## **EPA Comments**

**SUBJECT:** Comments on “DRAFT REPORT - TVA Shawnee Fossil Power Plant”

Re: Response to Recommendations  
USEPA CCR Impoundment Assessment DRAFT Report  
Shawnee Fossil Plant (SHF)  
Paducah, Kentucky

TENNESSEE VALLEY AUTHORITY (TVA) – COMMENTS ON COAL ASH SITE ASSESSMENT ROUND 11 DRAFT REPORTS FOR ALLEN (ALF), BULL RUN, (BRF) COLBERT (COF), CUMBERLAND (CUF), GALLATIN (GAF), JOHN SEVIER (JSF), JOHNSONVILLE, (JOF) KINGSTON (KIF), PARADISE (PAF), SHAWNEE (SHF), WATTS BAR (WBF), AND WIDOWS CREEK (WOF) FOSSIL PLANTS

**Cross Section N - Ash Pond 2  
Shawnee Fossil Plant  
Paducah, Kentucky**

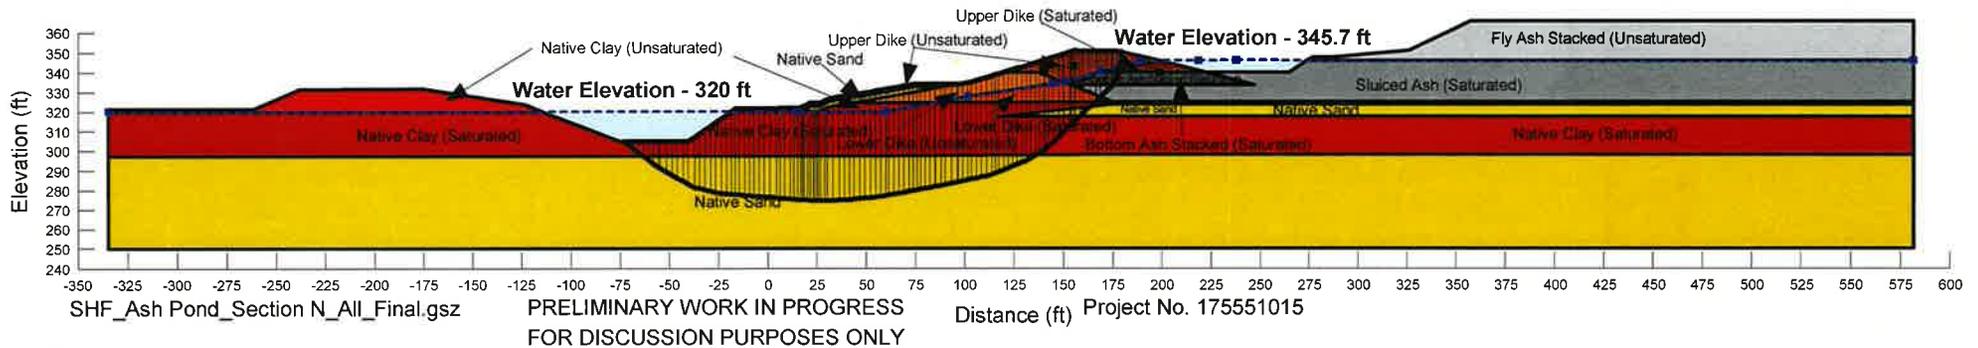
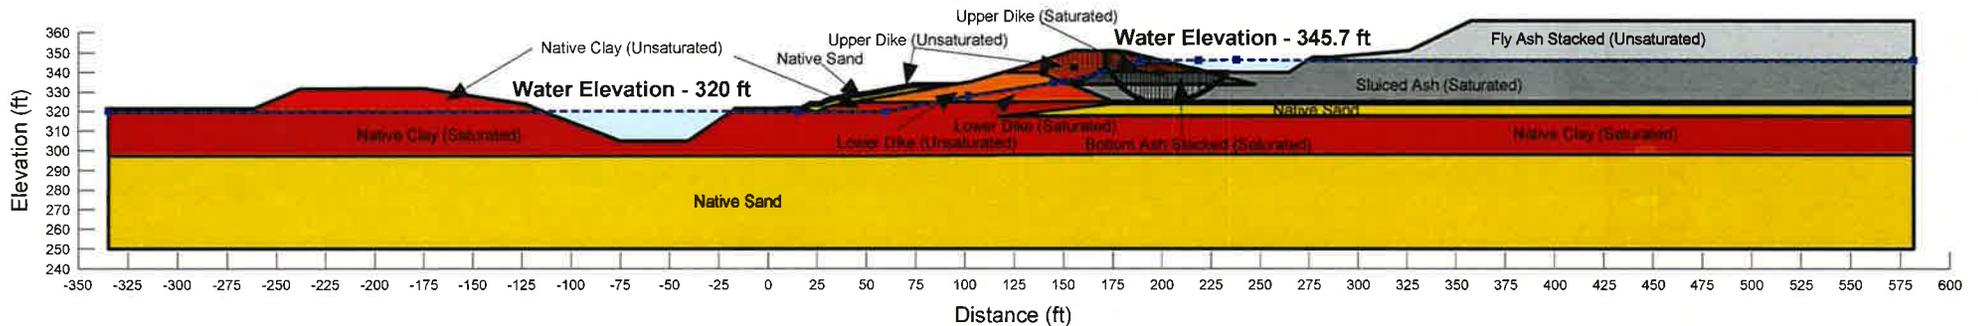
1. Include the results of the seismic stability analysis in the appendix as it is the primary reason why Ash Pond 2 is given a poor condition rating.
2. On page 11, section 3.3, first two sentences, replace “inspection” with “assessment” in each sentence.
3. On page 11, section 3.3, first sentence of second paragraph, add “2” after “Ash Pond No.”
4. On page 14, section 5, Conclusions, the rationale for the rating should also include the statement found on page 9, section 3.1.2: “No liquefaction potential evaluations have been performed to date for the Ash Pond 2 dikes, but may be warranted given that a portion of the upper dike is founded on sluiced ash (as described below), which is susceptible to liquefaction.”

***O'Brien and Gere Report Section 6:*** *Based on the findings of our visual inspection and review of the available records for the Ash Pond No. 2, O'Brien & Gere recommends that the required seismic slope stability analysis be performed for critical dike slopes. The seismic loading induced by the MCE (2% probability of exceedence in 50 years) should be applied in the analysis. In addition, the seismic analysis should include an evaluation of liquefaction potential, considering that the inboard portion of the last 10 foot vertical dike raising was founded on sluiced ash material, which can be subject to liquefaction. These analyses should be completed within one year from the date of this report.*

Based on the results of the liquefaction potential assessment, residual strengths were assigned to the liquefied materials and post-earthquake static stability analysis was performed for Section N. A description of the methodology and the results (slope stability cross section, including table of material parameters) are attached. The results indicate that Section N has a factor of safety greater than or equal to the target threshold value of 1.0; thus, the slope is judged to remain stable and will not undergo significant liquefaction-induced deformations due to the 2,500-year earthquake.

Because the post-earthquake stability analysis (with liquefied/reduced strengths) produced acceptable results, no further seismic analysis is deemed necessary.
